**Subject: Changes to NEDO-33201 in Response to the NRC Audit of the Probabilistic Risk Assessment Supporting Chapter 19 of the ESBWR Design Certification Application**

1. Markups to NEDO-33201 Draft Rev 5, ESBWR Probabilistic Risk Assessment

**Markups to NEDO-33201 Draft Rev 5,  
ESBWR Probabilistic Risk Assessment**

Figure 22.16.4-31. (Updated) LOCA – RWCU Break Outside Containment (Mode 5)

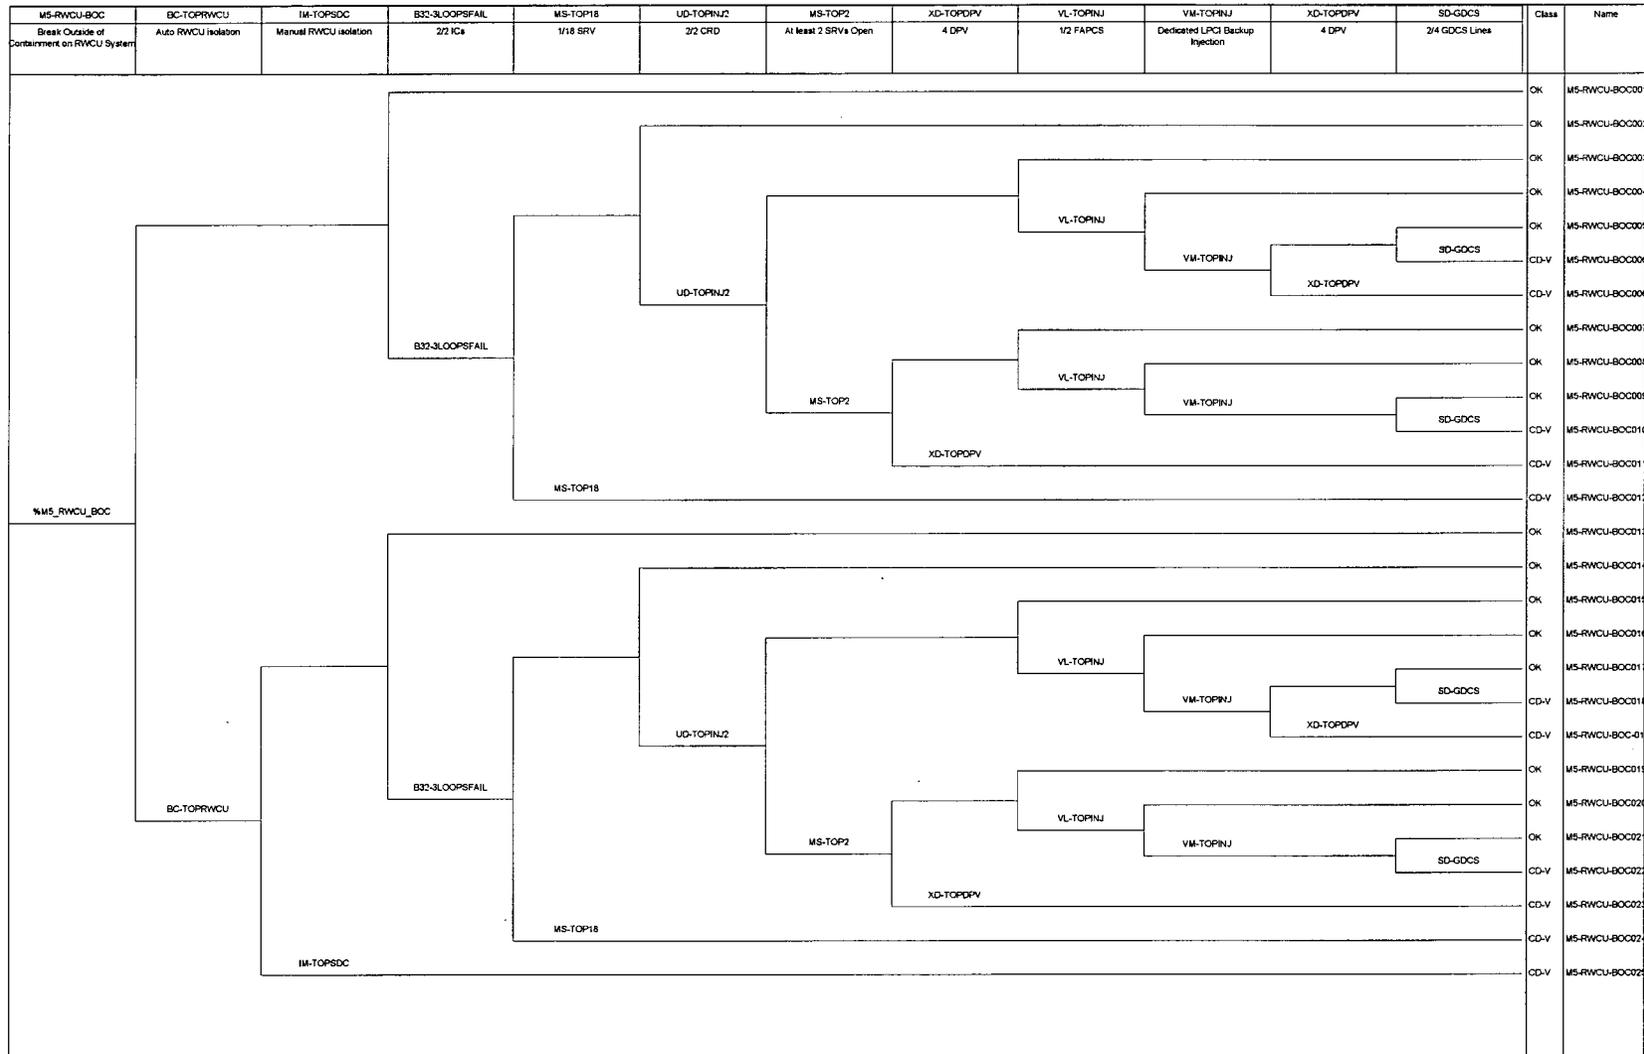
The RWCU/SDC Break Outside of Containment (BOC) event trees have been modified to include a top event for four DPVs actuating prior to GDCS actuation. This modification makes the RWCU/SDC BOC trees consistent with other shutdown (SD) PRA event trees. This change slightly increases the SD risk values since new sequences are added. However, the contribution from these new sequences is negligible because they involve multiple failures of the injections systems. The Mode 6 event trees do not require depressurization, so this change has no impact on event trees “M6F-RWCU-BOC.eta” and “M6U-RWCU-BOC.eta”.

The updated Figures 22.16.4-31 and 22.16.4-32 for the RWCU BOC event trees for Mode 5 and 5 Open are shown as below. In the Mode 5 and Mode 5 Open event trees, top event XD-TOPDPV has been added before top SD-GDCS. Four new core damage sequences are generated, which are also classified as CD-V (i.e., bypassing the containment):

- M5-RWCU-BOC006A
- M5-RWCU-BOC-018A
- M5O-RWCU-BOC005A
- M5O-RWCU-BOC016A
